Device XC886CM-6FF
Marking/Step ES AB
Package PG-TQFP-48

This Errata Sheet describes the deviations from the current user documentation. The module oriented classification and numbering system uses an ascending sequence over several derivatives, including already solved deviations. So gaps inside this enumeration can occur.

Figure 1 Critical Cases for Power up/ Power down when $V_{residual} > 500mV$

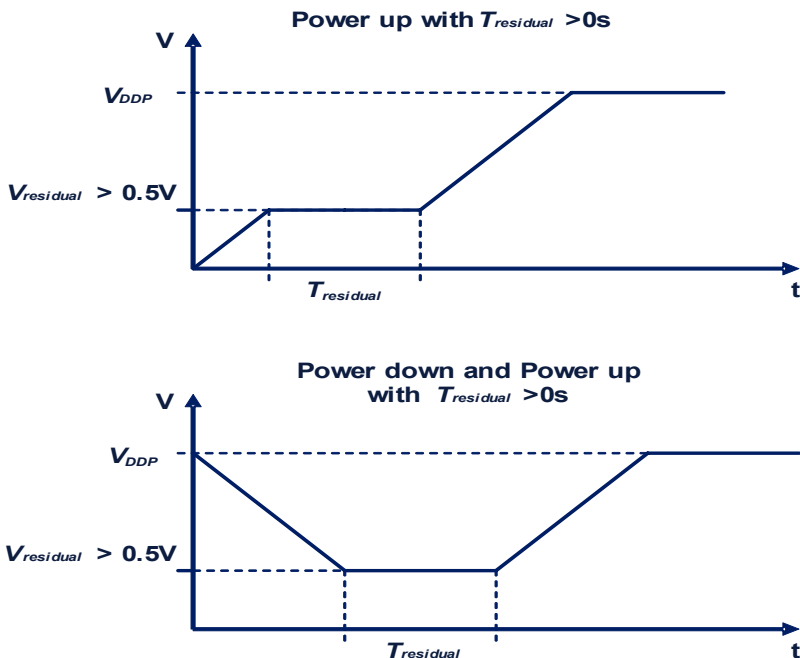
Due to the limitation of the EVR, the reset toggling may occur during the power up. To prevent the reset toggling issue for power up, the following conditions must be met :

1. For power up, the rising time must be less than 2ms/V.
2. The power down time must be more than 0.2ms/V.
3. A permanent V_{DDP} residual voltage is less than 500mV.

In case of V_{DDP} residual voltage is more than 500mV, the holding time of residual voltage affects the reset toggling issue. **Figure 1** shows the critical cases for power up/power down when the residual voltages is held for some time. **Figure 2** shows the uncritical case for power up and power down when the power up is triggered immediately after power down. In case of a residual voltage due to immediate power up after power down, the users have to contact IFX to ensure no power up failure.

None.

Figure 3

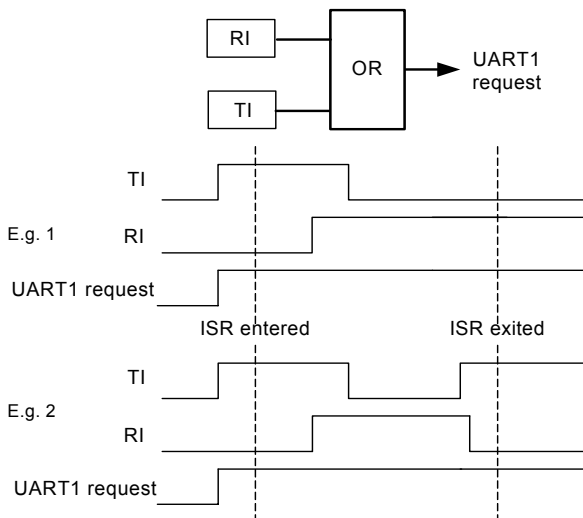
As illustrated in the simplified figure, the UART1 interrupt flags RI and TI are combined as one interrupt request output. These flags are located within the UART1 kernel, with a single interrupt request line as output from the kernel.

Being of interrupt structure 2, the interrupt request of UART1 is detected on the rising edge of a positive pulse.

The problem is that it may occur at some point in the application, that any new UART1 interrupt request can no longer be detected after a return-from-interrupt (reti) due to service of earlier event(s). This happens when the following conditions are true:

1. UART1 events are serviced by interrupt (i.e. flags are checked and cleared only in the interrupt routine ISR),
2. Either RI or TI is set at any one time throughout the ISR (even while the other is cleared) such that at least one of the flags is still set after reti, causing the UART1 request line, which is an OR-function of the two flags RI and TI, to remain set throughout the ISR and after reti.

There are two suggested workaround:

1. If other events of interrupt node XINTR8 (EX2) need not be enabled for interrupt, disable this interrupt node and use software polling of the flags instead.
2. Before return from interrupt, check again if RI or TI is (still) set (due to new request since the last check). If so, jump and execute the ISR routine from start. Exit only when all flags are checked to be cleared. However, dummy

interrupt of the node may occur after return from interrupt, and should be ignored. Another drawback is if UART1 events are occurring at high rate, the CPU may be 'stuck' in the service routine of the UART1 interrupt for a long time.

Figure 6 FIFO structure

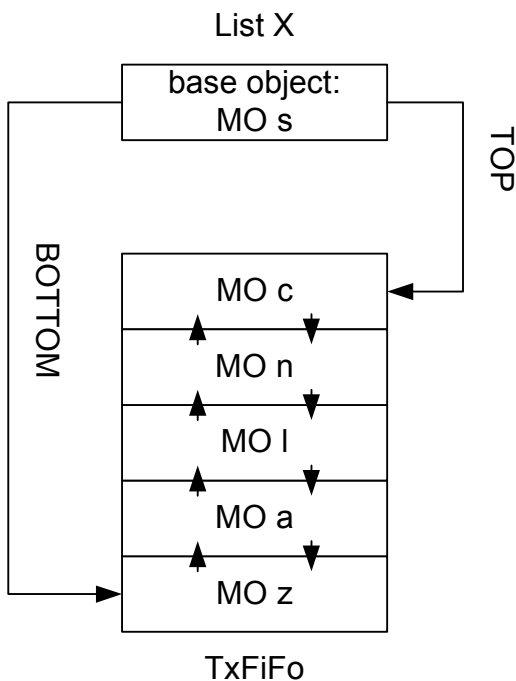
A Tx FIFO overflow interrupt will not be generated after the transmission of the Tx FIFO base object.

If Tx FIFO overflow interrupt needed, take the FIFO base object out of the circular list of the Tx message objects. That is to say, just use the FIFO base object for FIFO control, but not to store a Tx message.

Figure 9

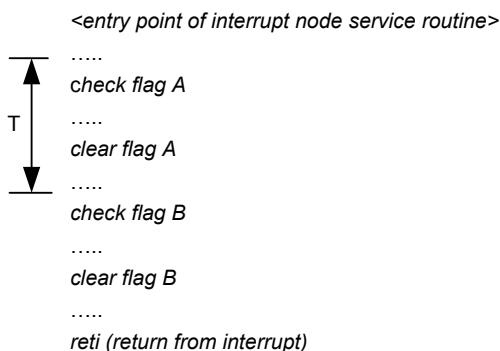
Consider the following NMI interrupt service routine pseudo-code, and scenario where a NMI interrupt source A event leads to interrupt request of the NMI node and CPU vectors to the NMI interrupt routine. Meanwhile, NMI interrupt source B and its flag becomes active any time in the duration indicated by T:

In this case, NMI flag B will be cleared as a standard procedure by the NMI interrupt routine in the current service. However, the pending interrupt request for the NMI node remains activated after RETI, as it is only cleared by hardware when CPU acknowledge the NMI interrupt and vectors to the NMI service routine.

This leads to following servicing of the NMI interrupt node again, but potentially no active NMI flag is found, i.e. dummy NMI interrupt service. The point to note is that the NMI interrupt source B is not lost, as it was actually serviced in the current service of the NMI interrupt node.

The recommendation is to ignore these dummy NMI interrupt vectoring.
